Access Compliance Report

Public Rights-of-Way

(Curb Ramps)

Intersection ID: 10019463	Main Street: ALEXANDER MARTIN AV	Cross Street: N/A	Location:	N
ADA ID: FADF4FD205B5	Ramp Type: Perp	Initial Pass/Fail: Fail	Overall Compliance: No	Severity Score: 22.5
Codes/Mitigation Info/Possible Solution		Field Measurements/Component Compliance

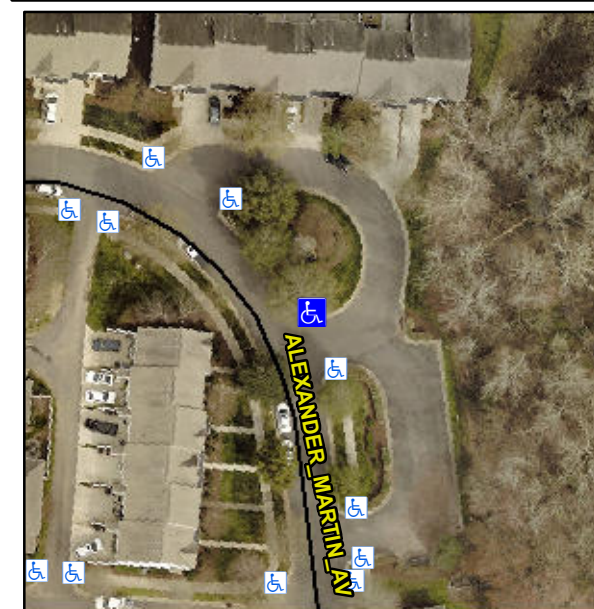
Not Found, R304.5.1, R304.2.2

Compliance	Description	Data	Compliance	Description	Data
N/A	Ramp Length (in)	51.0	No	Ramp Slope (%)	8.6
No	Ramp Width (in)	46.0	Yes	Ramp XSlope (%)	2.6
N/A	Flare Type LT	N/A	N/A	Flare Type RT	N/A
N/A	Flare Slope LT (%)	N/A	N/A	Flare Slope RT (%)	N/A
N/A	Flare Traversable LT?	N/A	N/A	Flare Traversable RT?	N/A
N/A	Landing Length (in)	N/A	N/A	DWS Provided?	N/A
N/A	Landing Width (in)	N/A	N/A	DWS Contrast?	N/A
N/A	Landing Slope (%)	N/A	N/A	DWS Length (in)	N/A
N/A	Landing X Slope (%)	N/A	N/A	DWS Full Width?	N/A
N/A	Landing Curb? (Y/N)	N/A	N/A	DWS Offset (in)	N/A
N/A	Shared Landing?	N/A			
N/A	Gutter Ponding?	N/A	N/A	Gutter Slope (%)	N/A
N/A	Gutter Lip Ht (in)	N/A	N/A	Gutter X Slope (%)	N/A
N/A	Painted X Walk1?	No	N/A	Painted X Walk2?	N/A
	X Walk 1 Direction	To SE		X Walk 2 Direction	N/A
N/A	X Walk 1 Width (in)	N/A	N/A	X Walk 2 Width (in)	N/A
	X Walk 1 Slope (%)	2.4		X Walk 2 Slope (%)	N/A
	X Walk 1 X Slope (%)	3.8		X Walk 2 X Slope (%)	N/A

Remove & Replace Entire Ramp.
